24466 / 24467

For the references 2446601 and 2446602 Fiat have changed their corresponding OES references from one wear indicator to two wear indicators per set. Not used wear indicators have to be simply cut off during assembly.

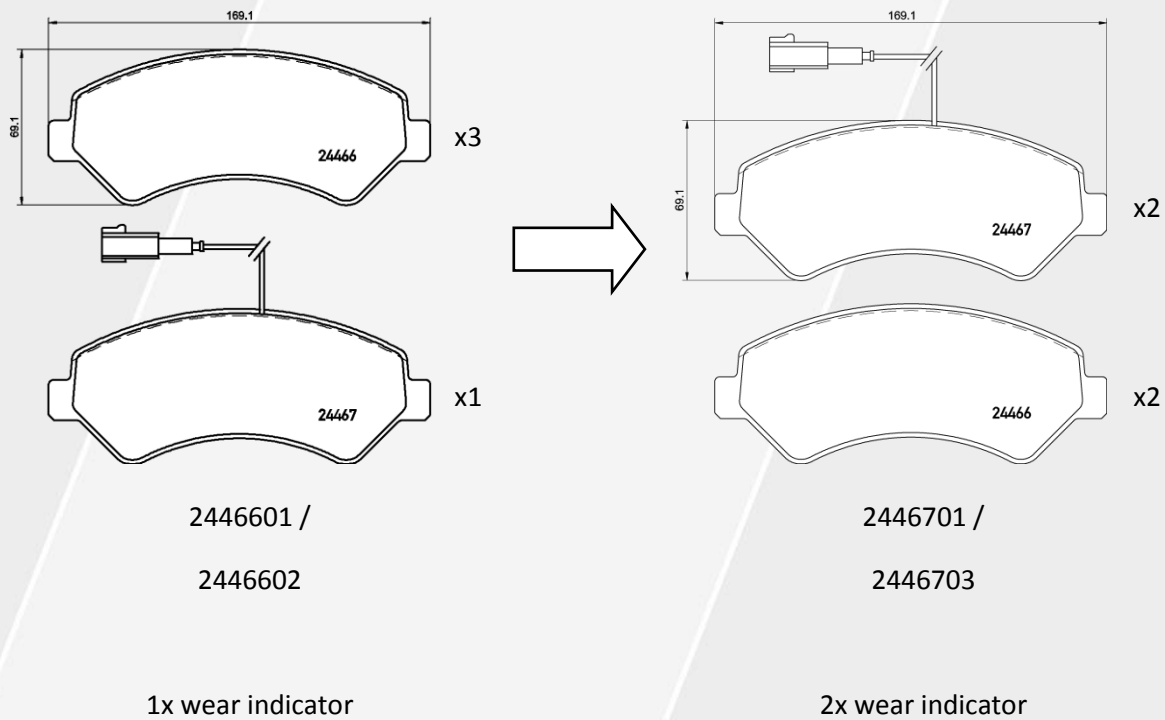
In order to be in line with the OES programme we will do the same changes. As a result of this we will do the following replacements:

2446601 → 2446701

2446602 → 2446703

Existing stock of 2446601 and 2446602 can be sold out. Please take care that only vehicles equipped with one wear indicator can use 2446601/2446602.

24466 / 24467

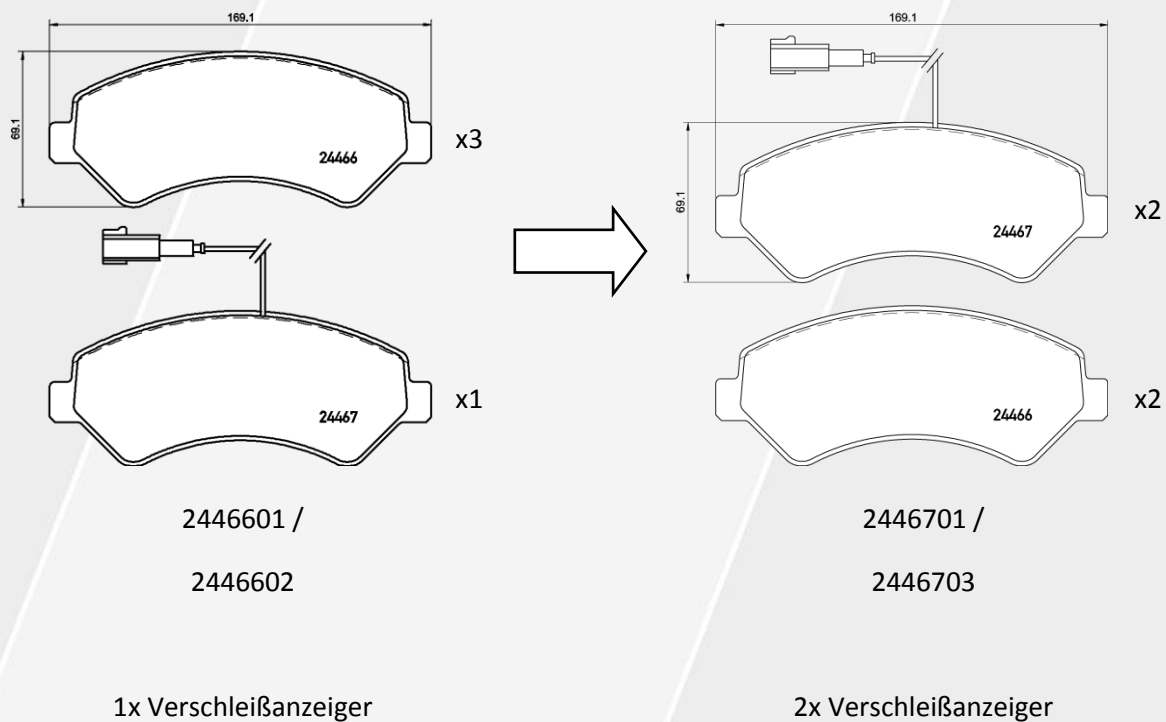
Für die Artikel 2446601 und 2446602 hat Fiat die entsprechenden OES Artikel von einem auf zwei Verschleißanzeiger pro Belagsatz umgestellt. Nicht benötigte Verschleißanzeiger können während der Montage einfach abgeschnitten werden.

Textar wird diese Änderung auch für die eigenen Produkte übernehmen und somit analog zum OES agieren. Als Resultat daraus werden folgende Ersetzungen vorgenommen:

2446601 → 2446701

2446602 → 2446703

Noch existierender Bestand kann verkauft werden. Bitte achten Sie während der Montage darauf, dass nur Fahrzeuge mit einem Verschleißanzeiger die Artikel 2446601/2446602 nutzen können.
